**SUBJECT: Transmittal of Responses to AP1000 DSER Open Items**

1. List of the AP1000 Design Certification Review, Draft Safety Evaluation Report Open Item Responses transmitted with letter DCP/NRC1628
2. Proprietary AP1000 Design Certification Review, Draft Safety Evaluation Report Open Item Responses dated September 23, 2003
3. Non-Proprietary AP1000 Design Certification Review, Draft Safety Evaluation Report Open Item Responses dated September 23, 2003

## Draft Safety Evaluation Report Open Item Response

Figure 3.8.4.3-1- 1 – Temperature Profiles In Structural Module Wall During Initial Part of Thermal Transients

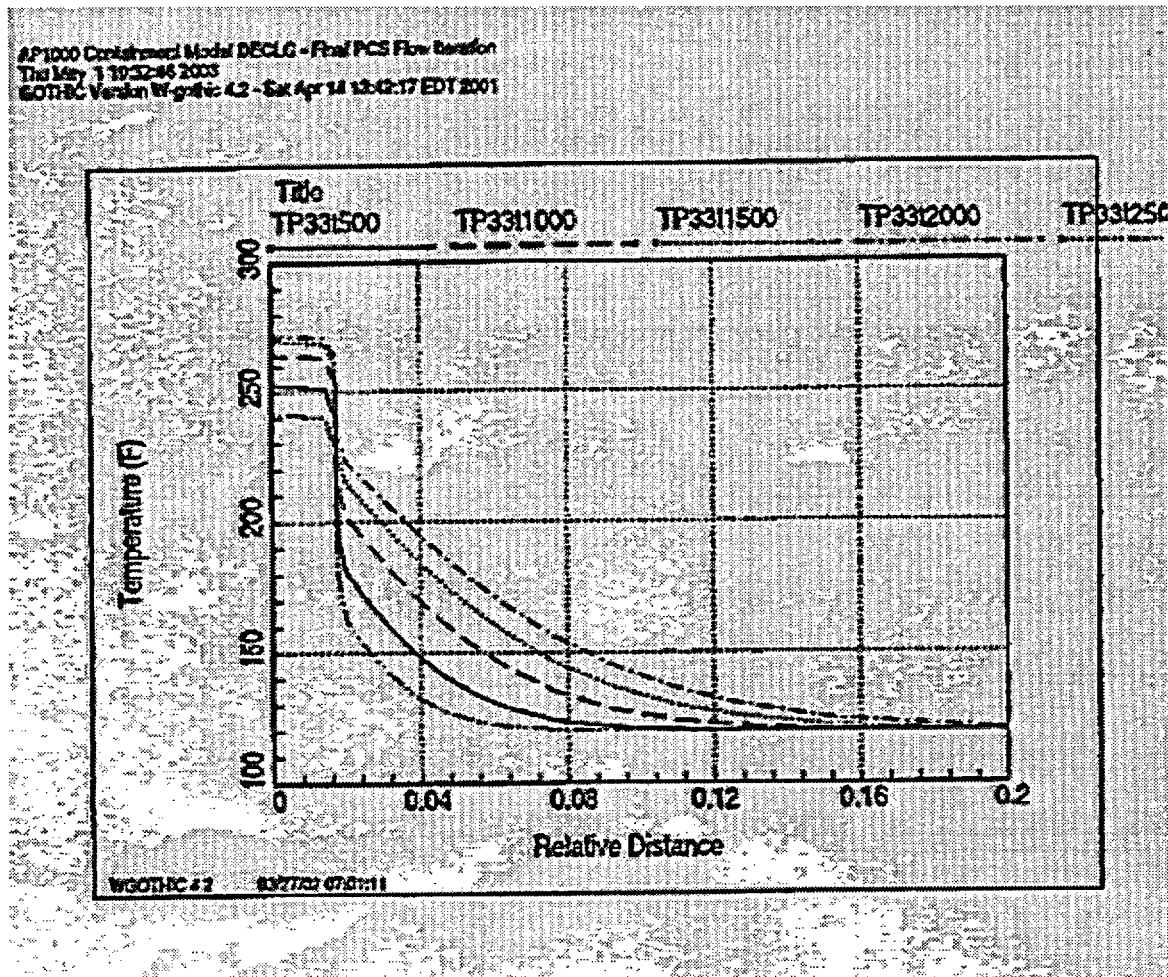
The applicant referenced DCD Tier 2 Figure 3D.5-9 in its response to RAI 220.015; however, it does not appear to have considered the effect of rapid increase in compartment temperature. Based on its review of the selected calculations, the staff could not reach a conclusion that the applicant has adequately addressed the effects of thermal transients on concrete filled steel modules. The analysis approach for the thermal transient inside the IRWST is discussed in Subsection 3.8.3.3 of this report, and has been found to be acceptable. However, for subcompartment locations inside containment (other than the IRWST) and locations outside containment, rapid heat-up of the steel plate of the structural wall modules must be considered in the analysis and design of the structural wall module. The concern is that for a rapid temperature transient, the mismatch in thermal conductivity between the steel faceplate and the concrete could impose significant thermal stresses on the faceplate, studs, and concrete core. This could potentially result in degradation of the faceplate/concrete bond and invalidate the assumption of composite behavior. The applicant needs to evaluate the thermal transients that can occur in the various subcompartments, and demonstrate that no unacceptable degradation would result from differential thermal expansion of the steel and concrete throughout the entire transient. This is Open Item 3.8.4.3-1.

Structural modules are subjected to a rapid temperature transient in the event of a loss of coolant accident (LOCA) or a main steam line break (MSLB). The steel plate of the structural modules heats up most rapidly in the LOCA event. DCD Figure 6.2.1.1-6 shows the containment temperature response for the double ended cold leg break. Figure 3.8.4.3-1-1

Figure 3.8.4.3-1- 2 – Unlaxial Strip Plate

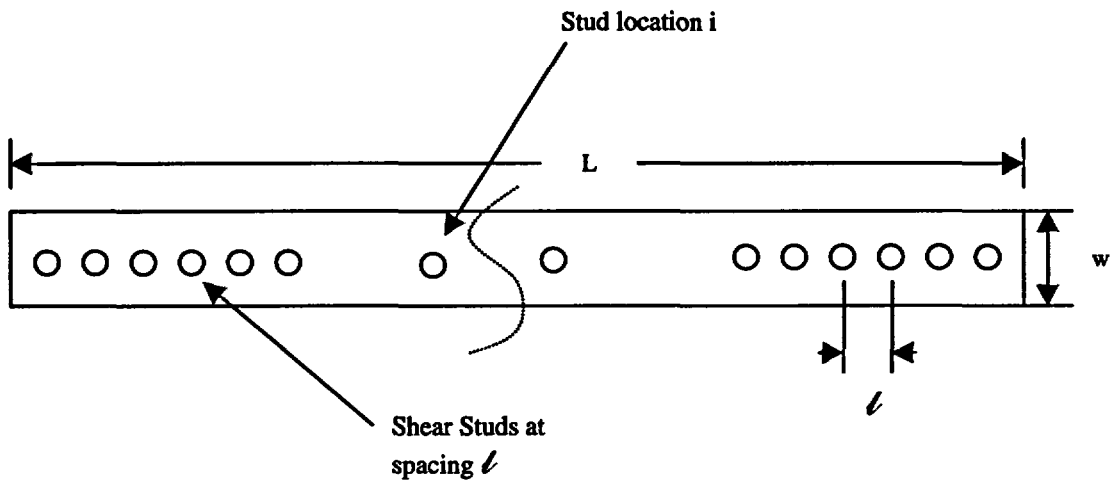
The uniaxial strip plate shown in Figure 3.8.4.3-1-2 represents a single row of shear studs in either the horizontal or vertical direction. A typical wall is considered with a length or height of 30'. Similar uniaxial models were evaluated for the AP600. The AP600 evaluation used a continuum representation of the shear studs to evaluate the interface between the steel plate, studs and concrete. The AP1000 evaluation uses a discrete representation of each shear stud.

Figure 3.8.4.3-1- 3 – Thermal Displacement Mathematical Formulations

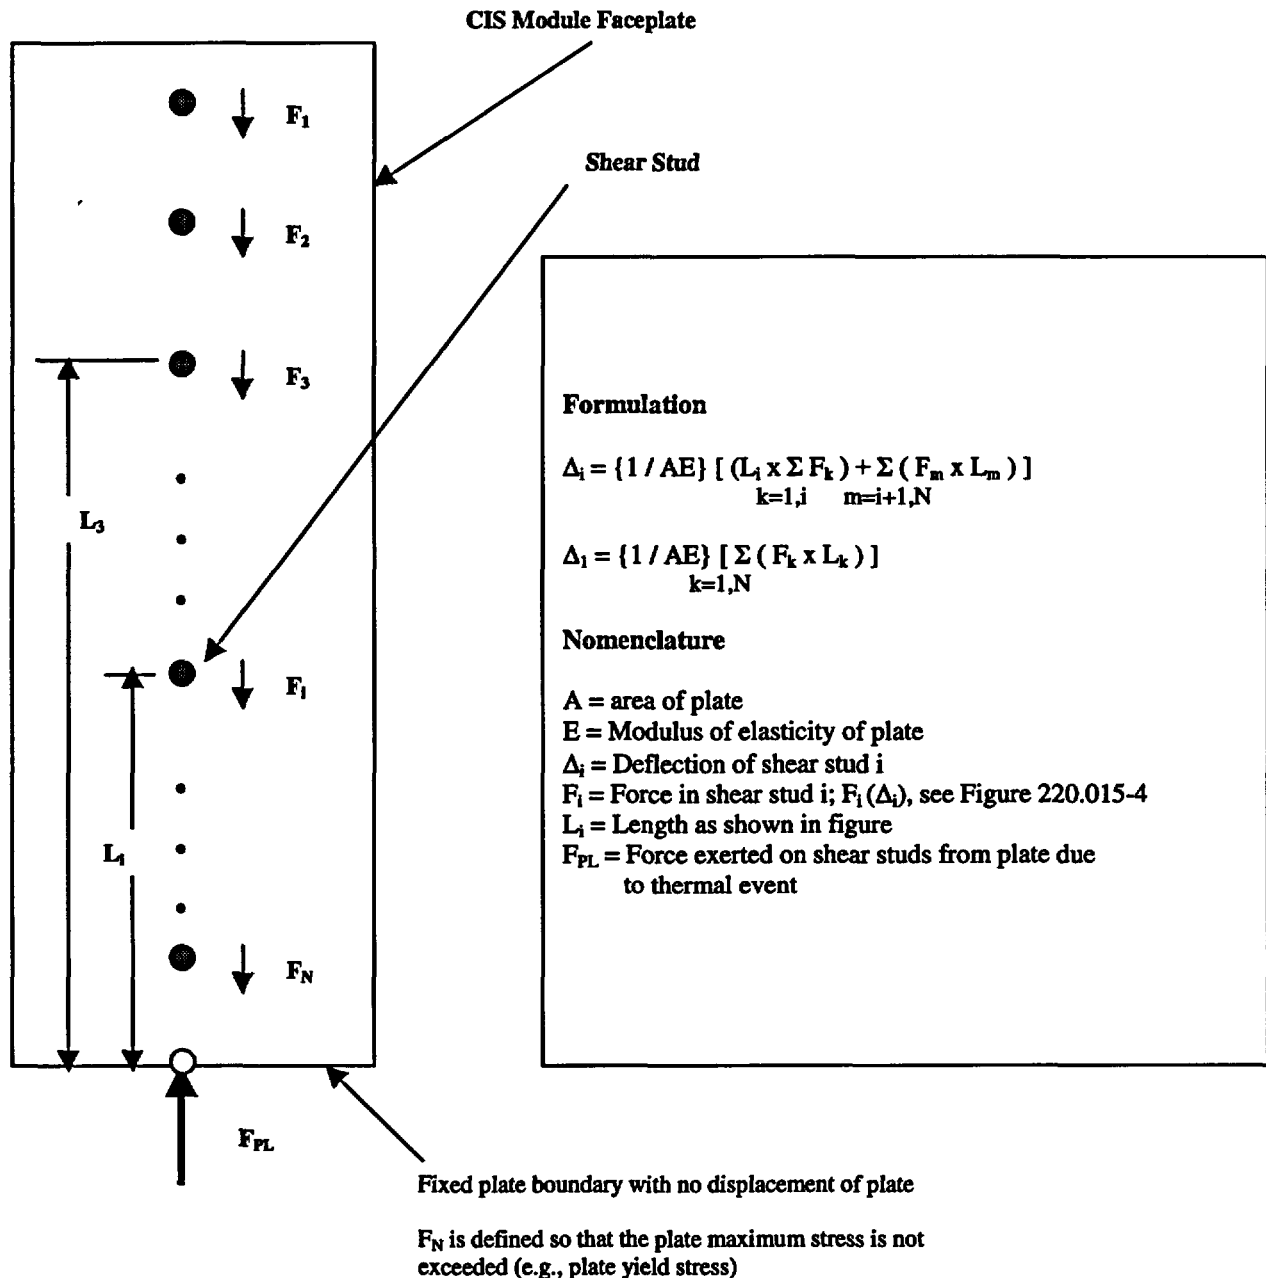
The formulation for the AP1000 thermal evaluation is given in Figure 3.8.4.3-1-3. The load in the shear stud is determined from a non-linear shear stud load-deflection curve based on Ollgaard and Slutter 1971 tests (Reference 3.8.4.3-1-1) as shown in Figure 3.8.4.3-1-4. The shear stud can transmit a peak load (24 kips) to the concrete even if there is localized deformation and crushing of the concrete in the vicinity of the shear stud. The test results show continued load capacity at deflections above 0.10 inches. This deflection of 0.1" is chosen as a representative limit for the evaluation. The force in a shear stud ( $F_i$ ) and its displacement is a function of the axial stiffness of the plate ( $AE/L_k$ ), the net force in the plate at stud location  $i$ , and the movement of the plate caused by the forces in the shear studs below the stud at location  $i$ .

Figure 3.8.4.3-1- 5 – Thermal Growth Shear Stud Loads

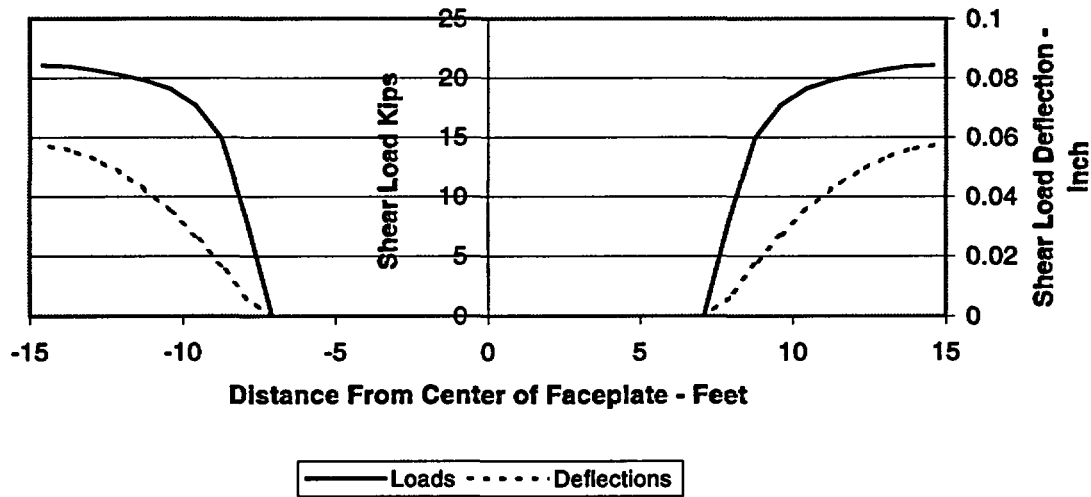
The shear stud load and deflections calculated using the uniaxial model for the carbon steel plate are shown in Figure 3.8.4.3-1-5. Figure 3.8.4.3-1-6 shows the stress in the faceplate when the surface plate is heated to 240°F during the initial part of the thermal transient. The maximum stress reaches yield in the central region of the plate. The maximum deflection in the shear stud (near the edge of the plate) is 0.057" (0.075" for the stainless steel plate) and is less

Figure 3.8.4.5-2-1  
Axial Load-Moment Interaction Diagram

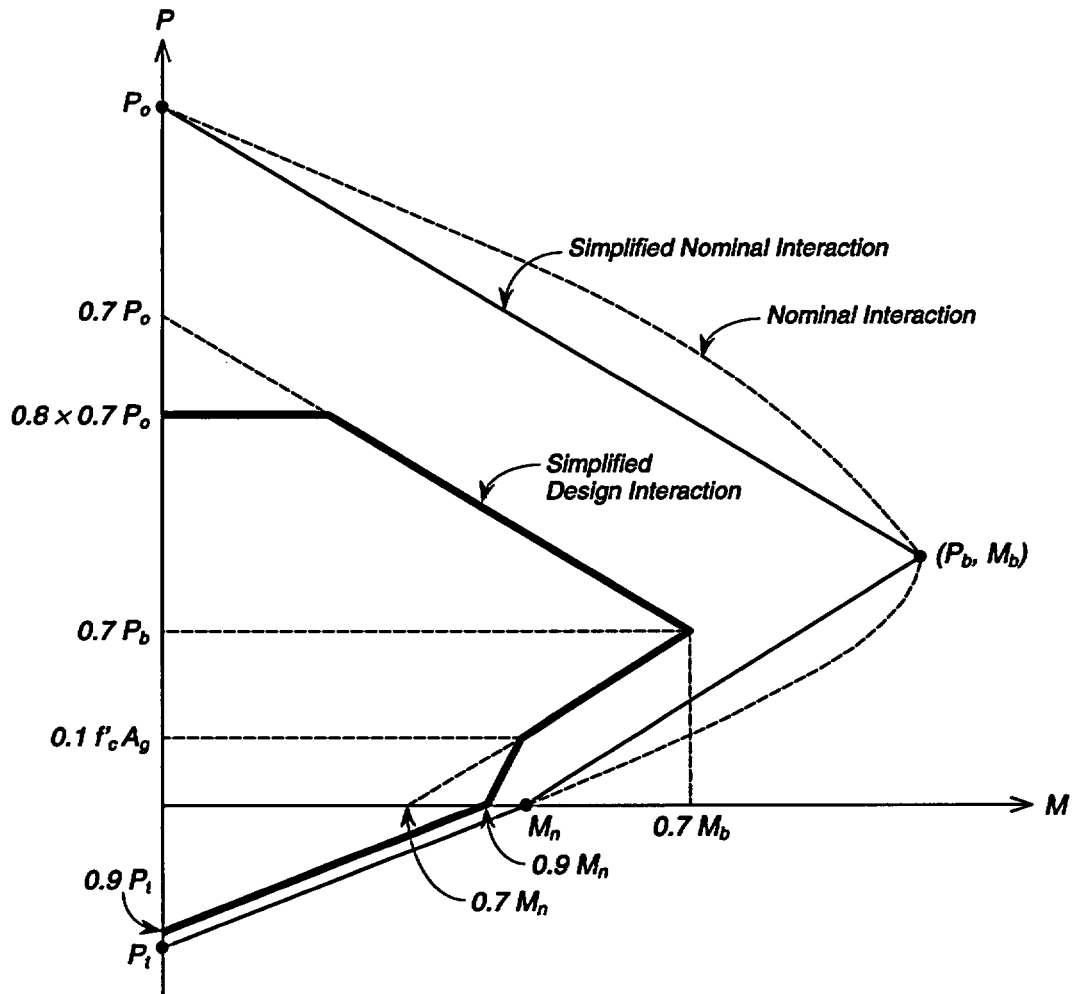
Figure 3.8.4.5-2-1 shows a typical interaction diagram defining the strength of a concrete section under combined axial force ( $P$ ) and bending moment ( $M$ ). It shows the nominal strength interaction as well as a simplified nominal interaction based on straight lines connecting the following key points:
